## **STAFF REPORT AND RECOMMENDATION TO THE DESIGN COMMISSION**

**CASE FILE:** LU 13-211599 DZM  
PC # 13-169941  
Lower Burnside Lofts

**WHEN:** January 23, 2014, at 1:30 p.m.

1 EXTERIOR ELEVATION - WEST  
 SCALE: 1/8" = 1'-0"

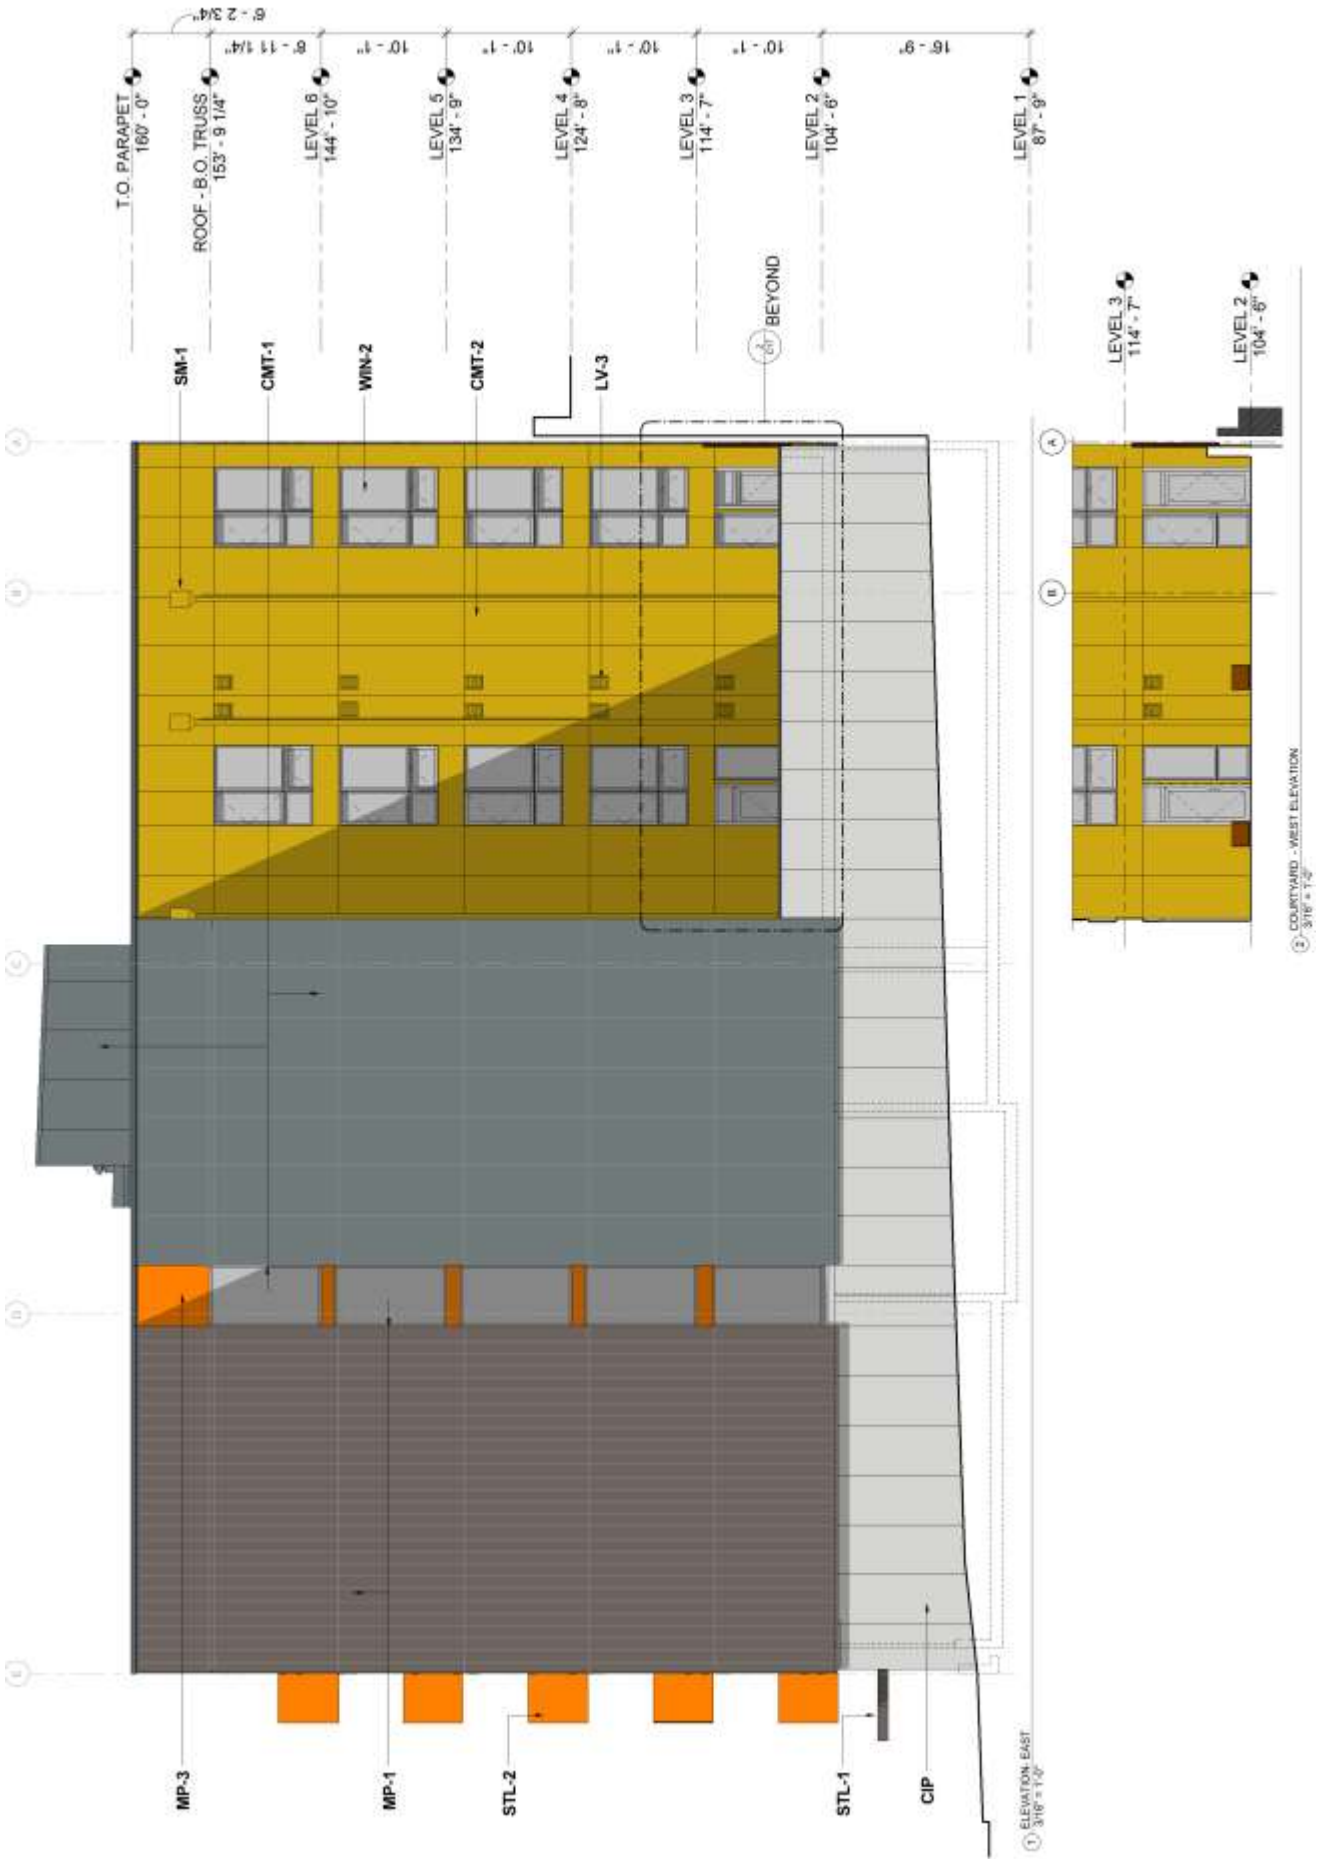
**Findings:** Although the proposed oriel on the west facade exceeds the standard width limit for encroachments into the right-of-way, it meets all of the other code guide requirements, including those for wall area and separation from other projected floor area. As a special design element it is integrated into the facade composition by alignment with the recessed roof deck above and with the edge of the garage entry recess below. The use of orange paint color also marks it and other elements as contrasting one-off accents. *This guideline is met.*

The applicant is seeking an exception to section F. Width of the building code guide Window Projection into Public Right-of-Way (IBC/32/#1) - Standards for windows allowed to project into public right-of-way. The request is for an oriel window projecting

into the SE 10<sup>th</sup> Avenue right-of-way that exceeds the standard maximum width of 12'-0" width by 5'-2". Exceptions are allowed in Design Review.

**Findings:** The proposed oriel window projects only 8% of the wall area and its width is only 17% of the wall's length. As evidenced in the findings for guideline C10 above, the proposed oriel is well integrated into the facade composition. It functions as an accentuation rather than a significant use of public space. *This exception request meets the approval criteria.*
